SUBJECT: Review Plan Approval for Raritan Bay and Sandy Hook Bay, New Jersey,  
Hurricane and Storm Damage Reduction Project, Port Monmouth Phase II

**Review Plan for  
Raritan Bay and Sandy Hook Bay, New Jersey  
Hurricane and Storm Damage Reduction  
Port Monmouth Phase II  
Flood Risk Management Components**

## PORT MONMOUTH PHASE II REVIEW PLAN COMMENTS FROM RMC

Figure 1. Project Area Location

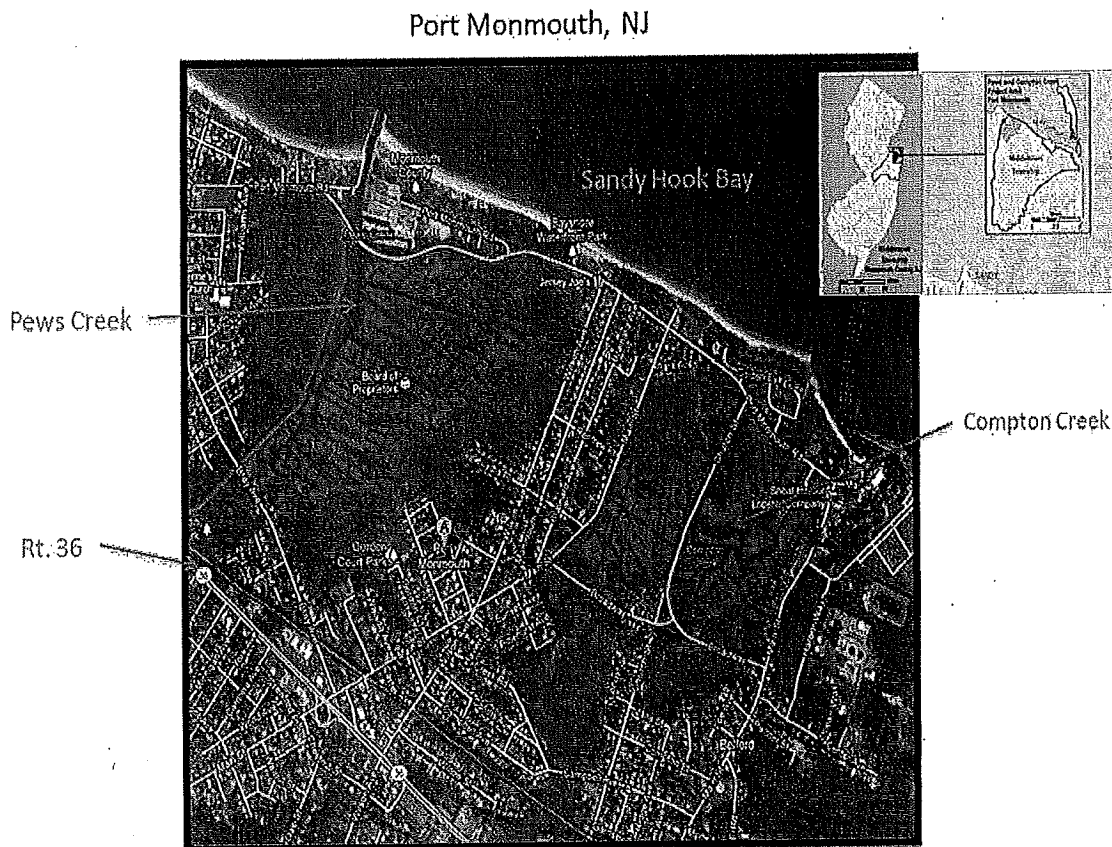
**COMMENT #5.** Figure 1: <<insert map of project location>>

**RESPONSE:** Concur. Project Location figure has been added.
